Rye College Artificial Multi-use Games Pitch. RR/2019/785/P 3G synthetic football pitch with goal recesses, spectator area, floodlights, perimeter fencing and changing facilities

Julian Luckett Chairman, Planning Committee Rye Conservation Society

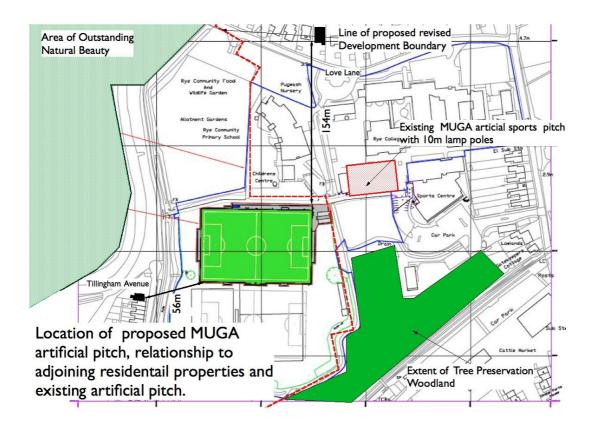
The relationship to the adjacent AONB boundary, the open fields to the north and west and the views from the upper town are important factors in any development in this location. We have attempted to show the impact of the light poles and the 8m fencing when seen from St Mary's tower and from the footpath along Tillingham Avenue. See attached MUGA 2&3. We believe that the impact is likely to be of a magnitude to require the applicant to provide their own photo-montages from salient viewpoints.

View from Tillingham Avenue footpath

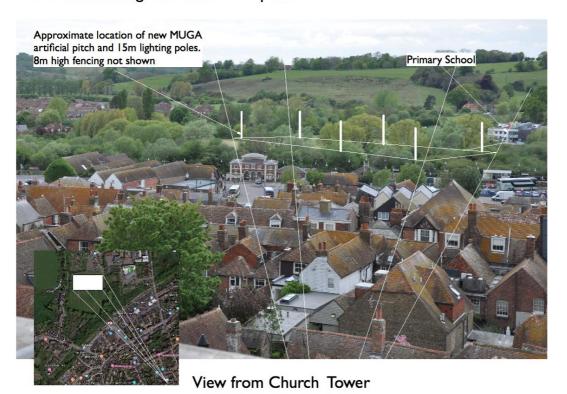
Much is made in the applicant's information of the tree line along the Tillingham Avenue footpath which they believe will reduce the effect of noise and light pollution on the houses. These are only 60m or so from the corner of the proposed pitch and flood lights. We would point out that this is a deciduous hedge with occasional trees as can be seen from the attached photos MUGA 4. Given the proximity of the floodlights to it and the height of the lamps above the ground, any such mitigation is likely to be limited.

Views into site from footpath along Tillingham Avenue show porous nature of vegetation
